NEI 91-04 Revision 1
(formerly NUMARC 91-04)

Severe Accident Issue Closure Guidelines

NUCLEAR
ENERGY
INSTITUTE

DECEMBER 1994

Seismic-IPE Pre-Closure Assessment for Evaluation of Outliers in Focused-Scope and Full-Scope SMAs

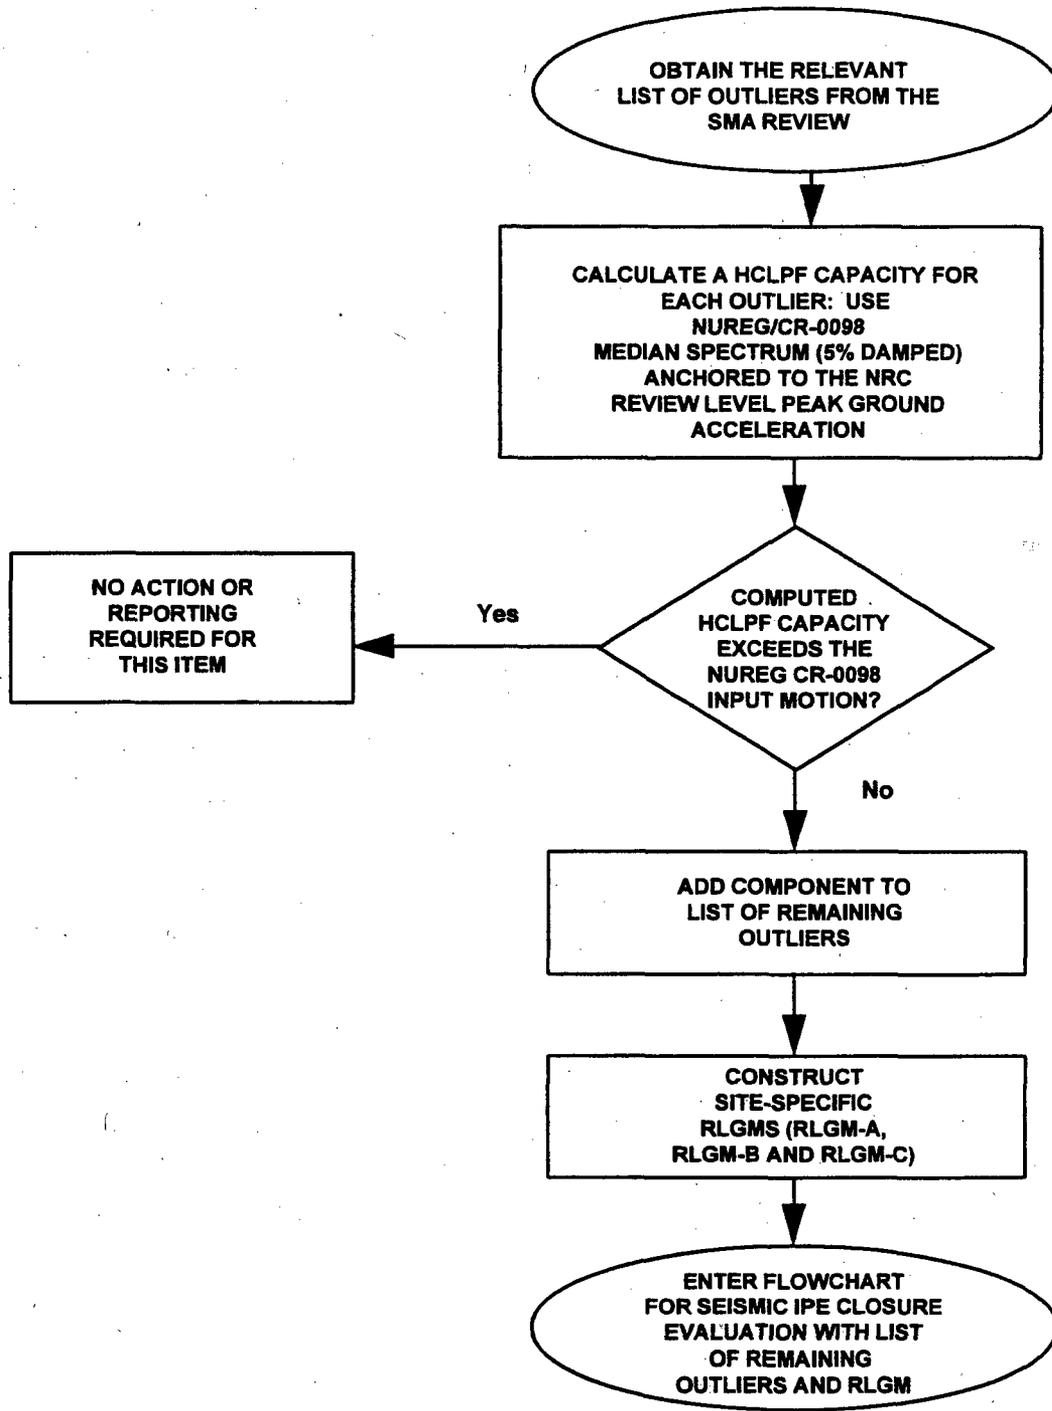
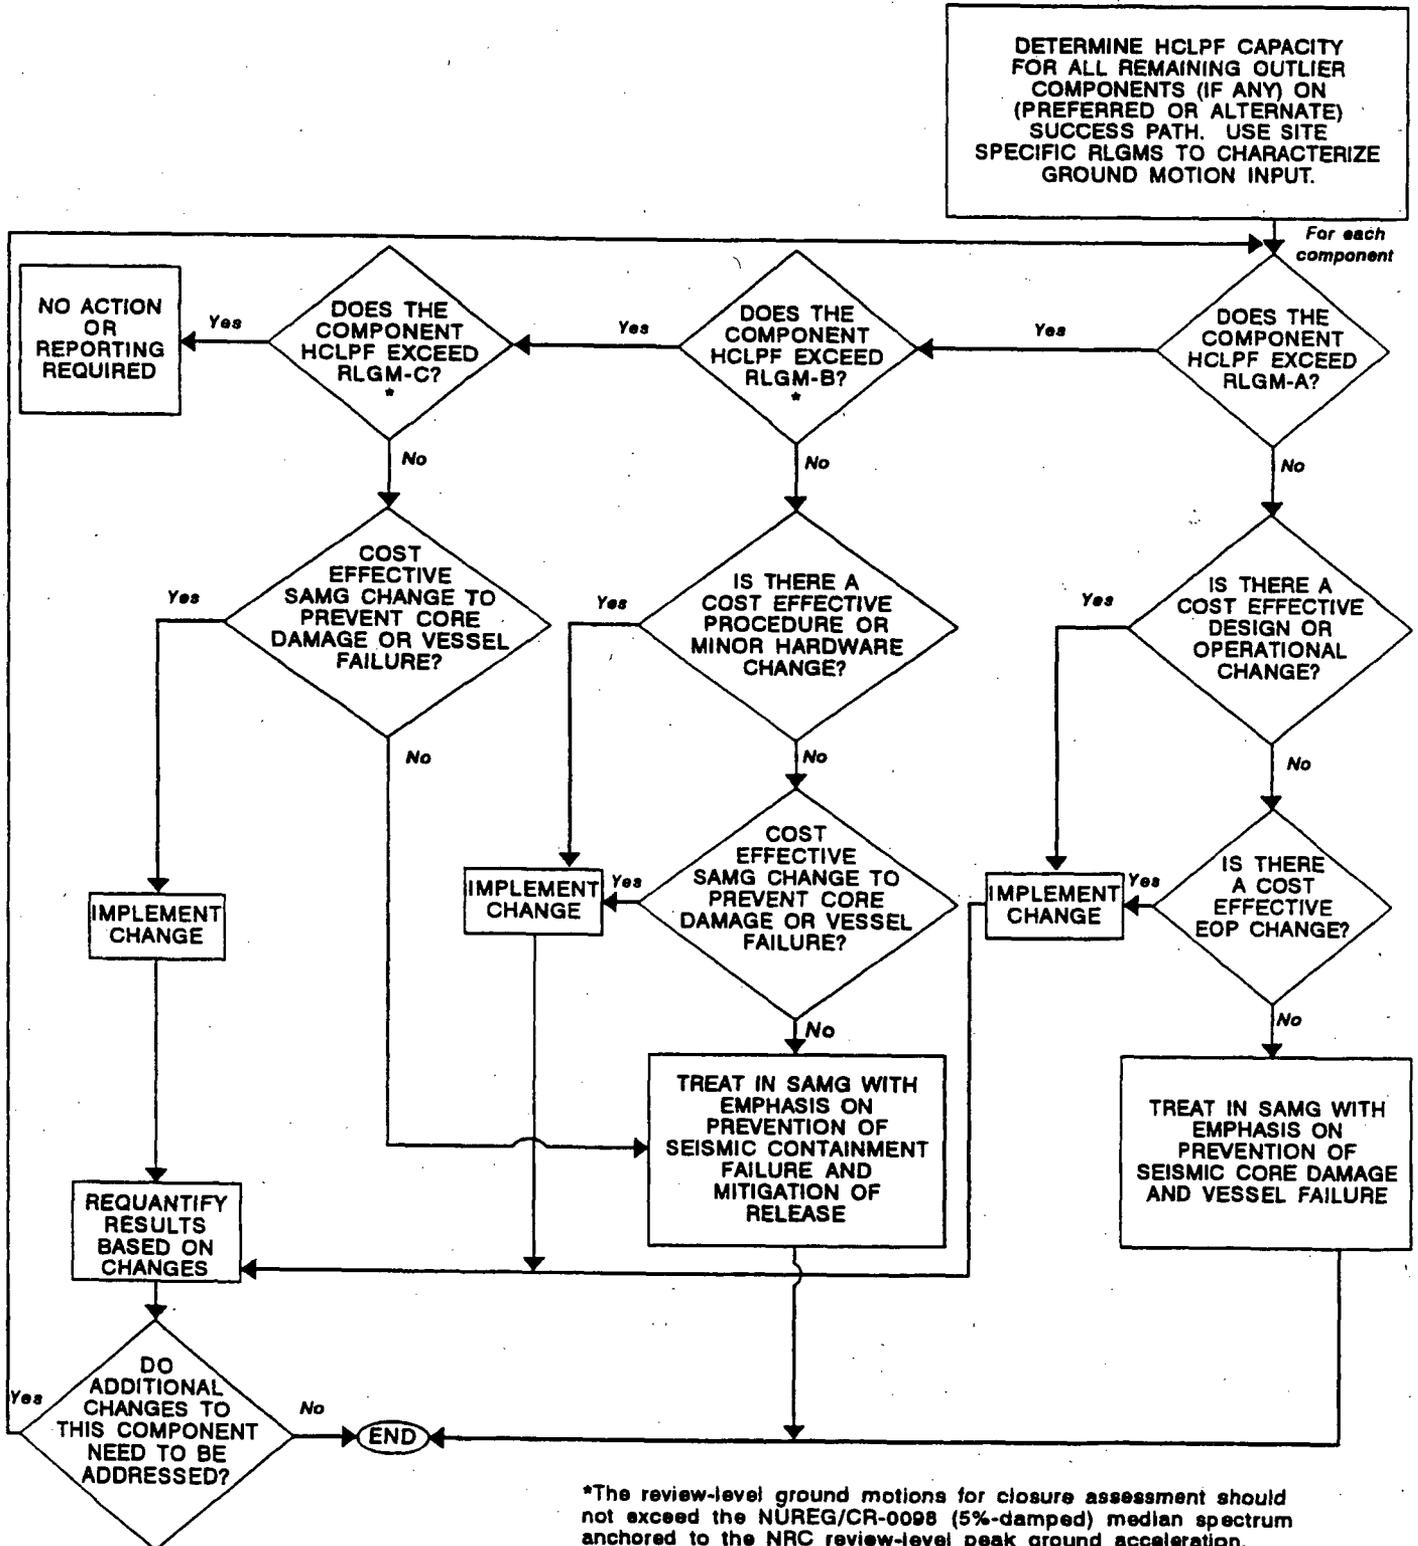
The term "review level ground motions (RLGMs)" (p.20) has not been clearly defined, and we cannot determine how this term compares with the "review level earthquakes (RLEs)," which is used in the NUREG-1407. The NRC has not reviewed References 6 and 8 (pp. 20 & 31). Therefore, we cannot determine if the RLGMs specified in these documents are consistent with those specified in the NUREG-1407, and if the recommended resolutions are acceptable to the NRC. However, these appear to add unnecessary complication and will lead to controversy regarding which hazard curves are used

The closure evaluation process should provide discussions on using the existing spectra the plant used in the original seismic design, by scaling, in addition to the discussion of "calculate HCLPF capacities...using the median NUREG/CR-0098 spectrum." The NRC does not require licensees to generate new spectra to meet the NUREG/CR-0098 specifications for the seismic IPEEE stated in NUREG/CR-0098, "Seismic Review of Selected Nuclear Power Plants."

NUMARC should also provide a discussion on how HCLPFs can be used in the evaluation process for closing severe accident issues. If the licensee does not provide HCLPFs, the NRC will calculate and use the HCLPFs in the process of resolving severe accident vulnerabilities resulting from seismic events.
